# SERVICE LETTER

No. 575

Subject: Nose Landing Gear System Inspection

Models Affected: PA-30 and PA-39 Twin Comanche

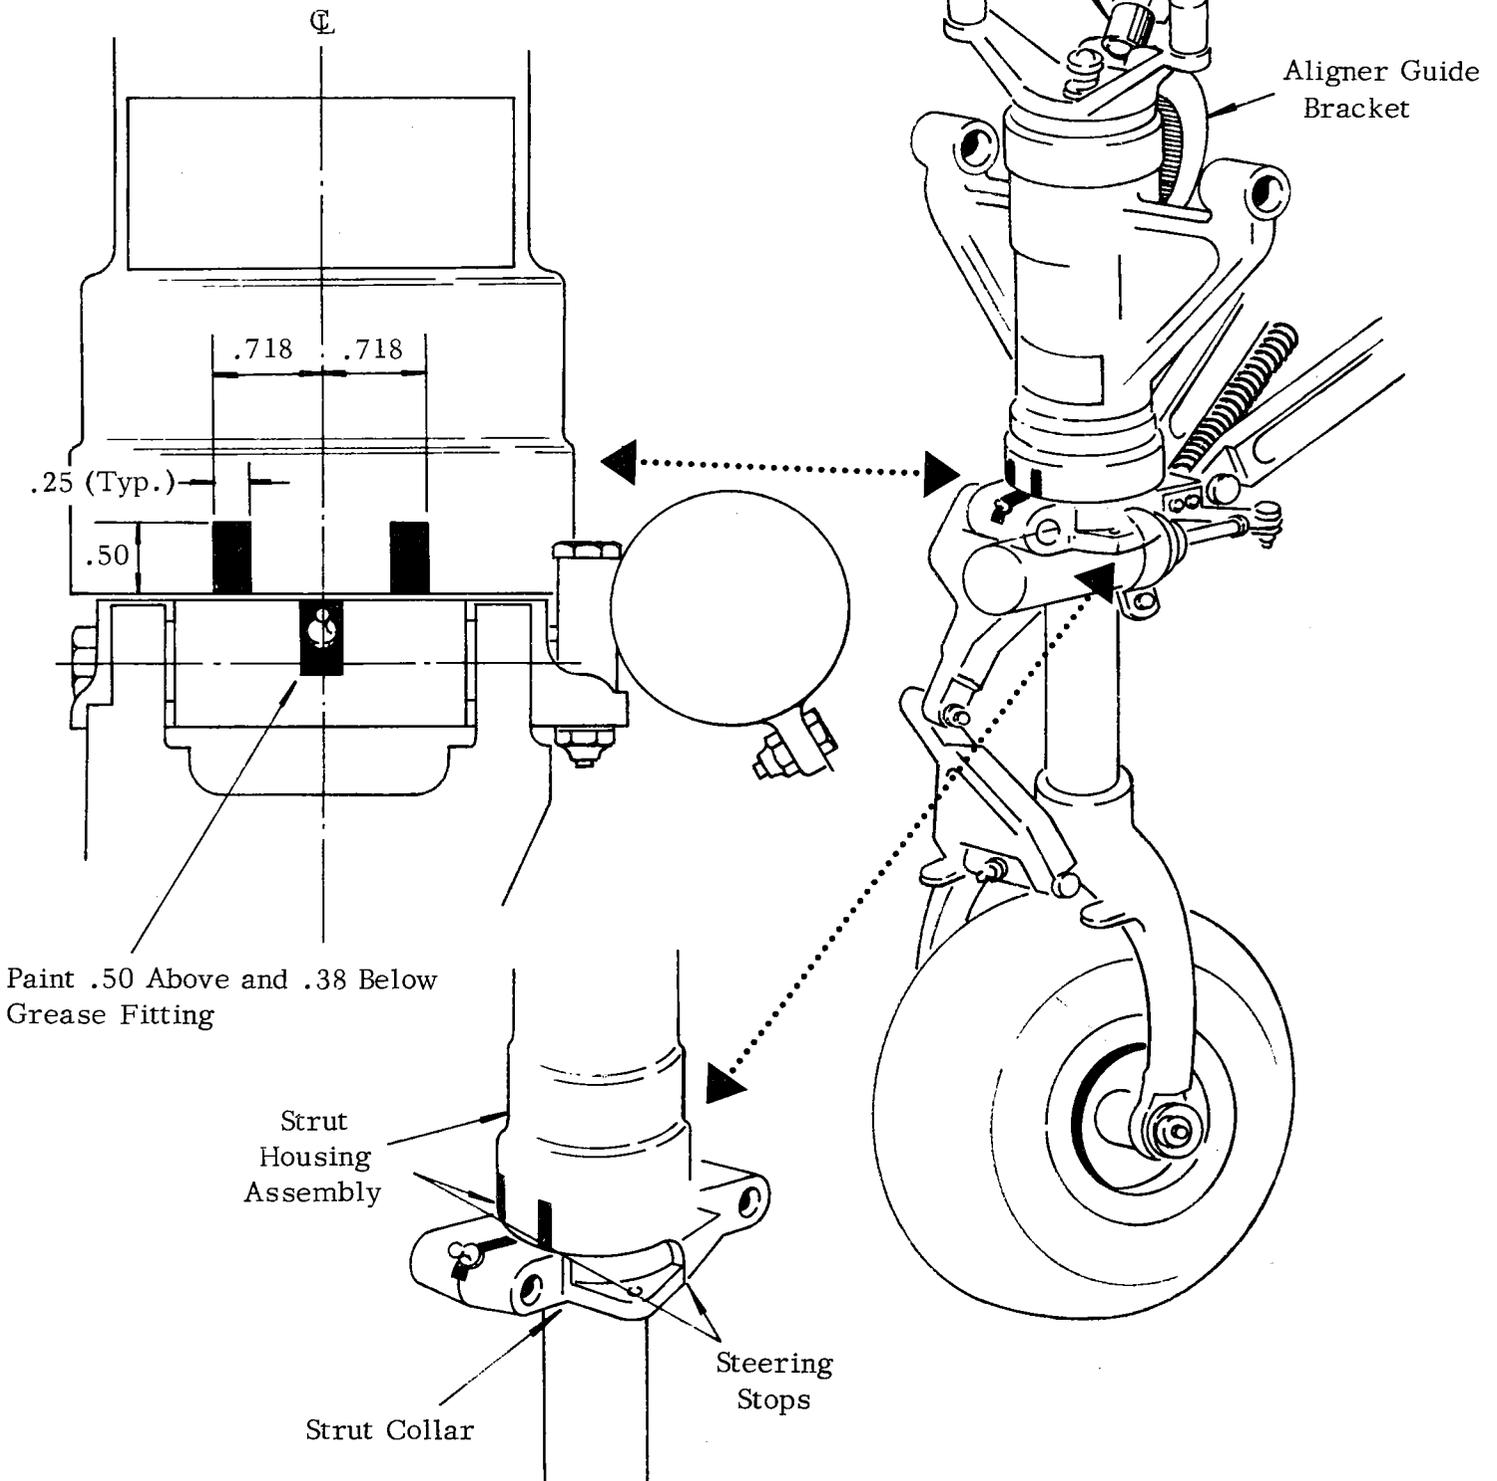
cycling, observe that the aligner roller is engaged within the nose gear aligner guide bracket channel (reference attached sketch for a pictorial description).

- a. If the aligner roller does not engage within the aligner guide bracket during gear cycling as specified above, it will be necessary to recheck nose gear steering travel limits.
4. Apply steering limit markings on the nose gear strut housing as denoted on attached sketch.

Note: Apply steering limit markings (red paint) on the strut assembly as shown.

Paint .50 Above and .38 Below Grease Fitting
